JACKSONS LANDING COALITION INC.

SUBMISSION TO THE INDEPENDENT PLANNING COMMISSION

Glebe Island Aggregate Handling Facility and Concrete Batching Plant

SSD 8544

MP05_0187 MOD 3

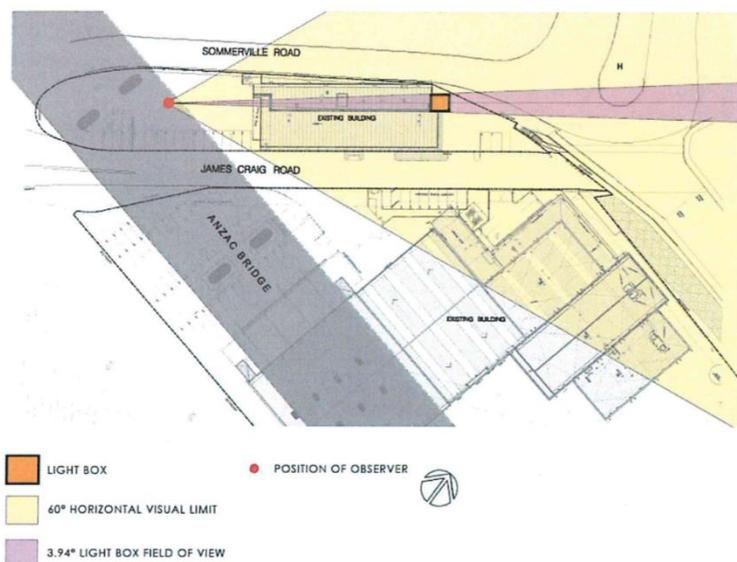
Figure 4 on page 7 is particularly interesting. It analyses the impact of the light box on views **from** the ANZAC Bridge to Sydney Harbour and the city skyline.

The proposed siting of the light box does not fall within any of the viewpoints or view corridors identified in the Master Plan for Rozelle and Blackwattle Bay Maritime Precincts. However, the DCP states that views from public places to the water and to landmarks should not be obstructed by development. The EA indicates that the proposed light box would obstruct views from the ANZAC Bridge towards the Sydney Harbour Bridge. Based on a 60 degree horizontal view limit, the light box would shield 3.94 degrees (6.66%) of the horizontal view from the closest point of the ANZAC Bridge to the light box, as shown in **Figure 4** (below).

There is a great deal of analysis for a structure measuring just 3m high and **4.7m wide** and sitting **below** the level of the ANZAC Bridge carriageway. Look at the remarkably narrow scope of the view obstruction in the picture above that they were concerned with in that case. Contrast this with the DPIE’s apparent lack of interest in the loss of views that would be caused by Hanson’s proposed **140 m** long silos. There is a clear inconsistency between the DPIE’s approach to the SCM development and its approach to the Hanson proposal.
